**AGENDA**
**PLANNING COMMISSION REGULAR MEETING**
**CITY OF FARMINGTON HILLS**
**OCTOBER 15, 2026 at 7:30 P.M.**
**FARMINGTON HILLS CITY HALL – CITY COUNCIL CHAMBER**
**31555 W. ELEVEN MILE ROAD, FARMINGTON HILLS, MICHIGAN 48336**
**Cable TV:** Spectrum – Channel 203; AT&T – Channel 99
**YouTube Channel:** https://www.youtube.com/user/FHChannel8
**www.fhgov.com (248) 871-2540**

**A. SITE PLAN APPROVAL 61-9-2026**

# City Planner Review
# October 9, 2026

**SUBJECT:** Preliminary Site Plan Approval SP 61-9-2026 – Jax Kar Wash - 30775 W. 12 Mile Rd – Parcel ID #22-23-14-101-015

SHEET
A.1

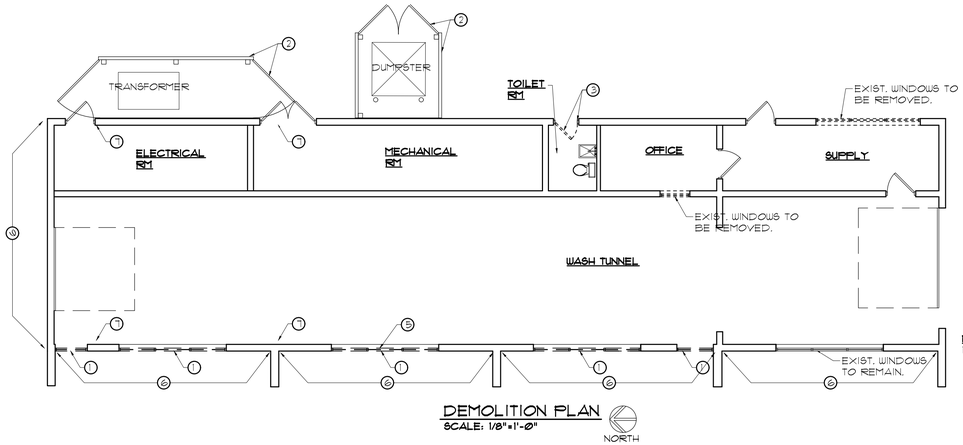
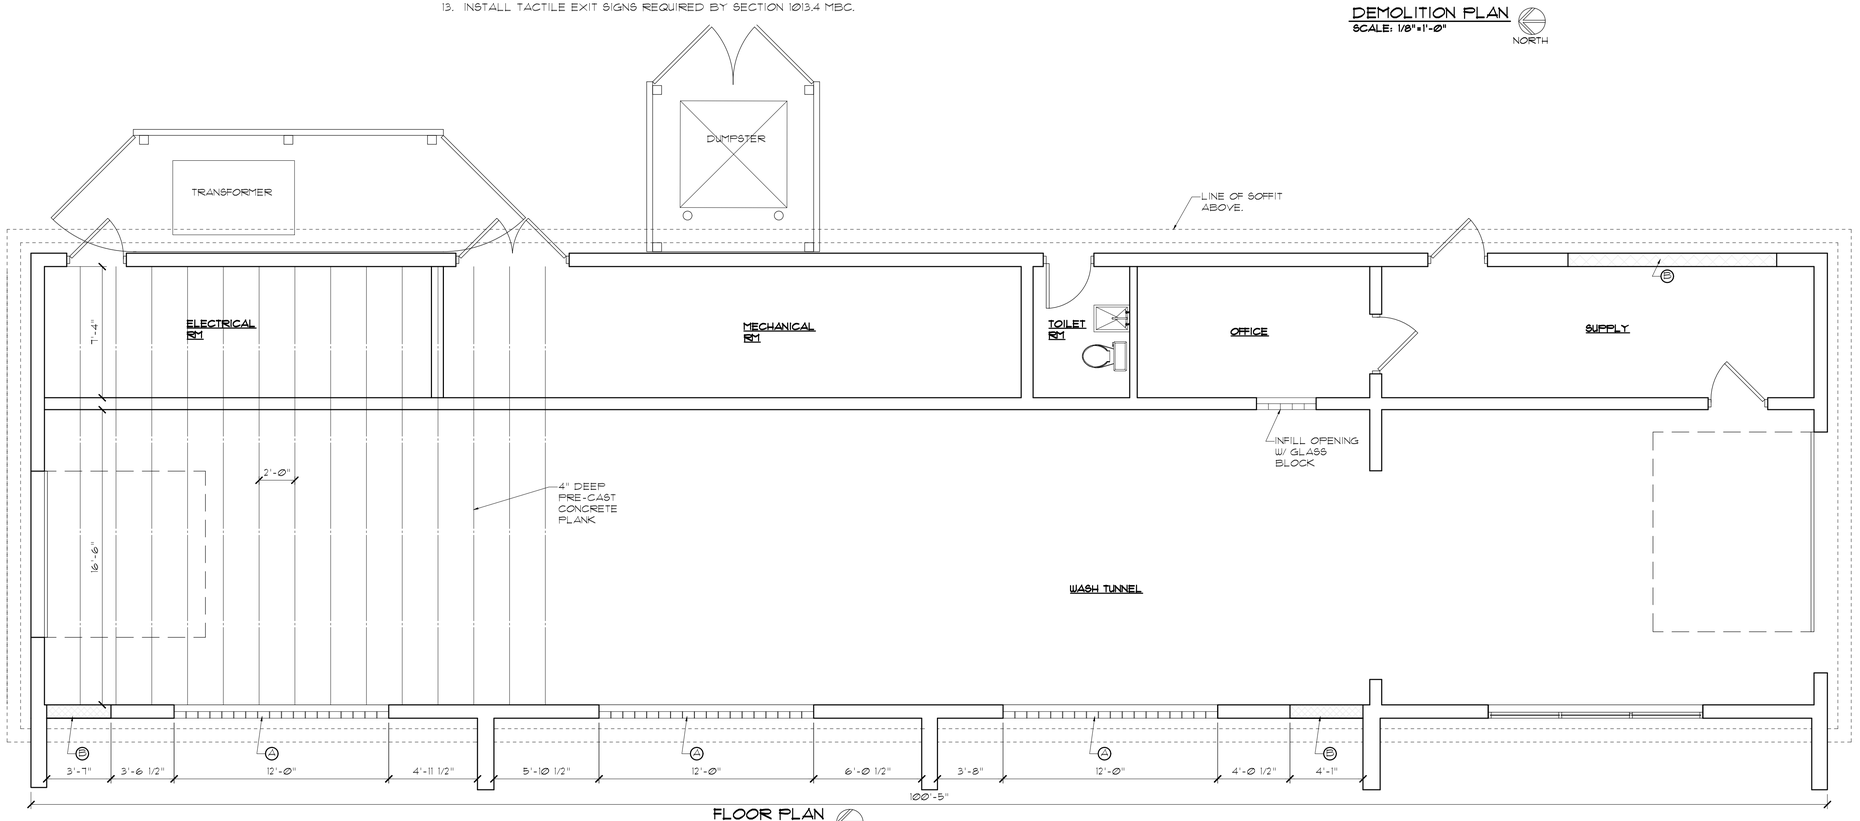
1) *The note about speakers and televisions on Sheet A.1 must be removed from the plan. If such equipment is proposed, the applicant must provide additional information about the equipment quantity, location(s), and intended use.*

2) *Update the cover sheet (A.1) to add an aerial photograph with parcel boundaries next to the location map.*

4) *The applicant must confirm the legal description is correct and include on the cover sheet (A.1)..*

SHEET
A.6

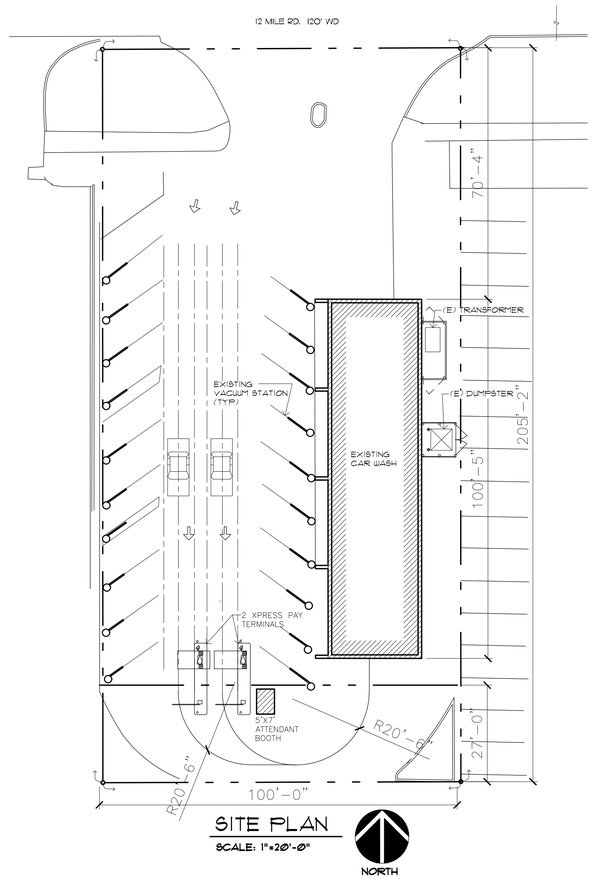
The site layout plan, property boundaries, and legal description included on sheet A.6 are not accurate and do not match the property records available in the City's BS&A and online GIS records. The applicant must remove sheet A.6 and update cover sheet (A.1) to include corrected legal description and include an aerial photograph with parcel boundaries next to the location map.

3) *The applicant must remove sheet A.6; the site plan layout is inaccurate and unnecessary as no site changes are proposed. Additional site information may be required if any site improvements are proposed.*
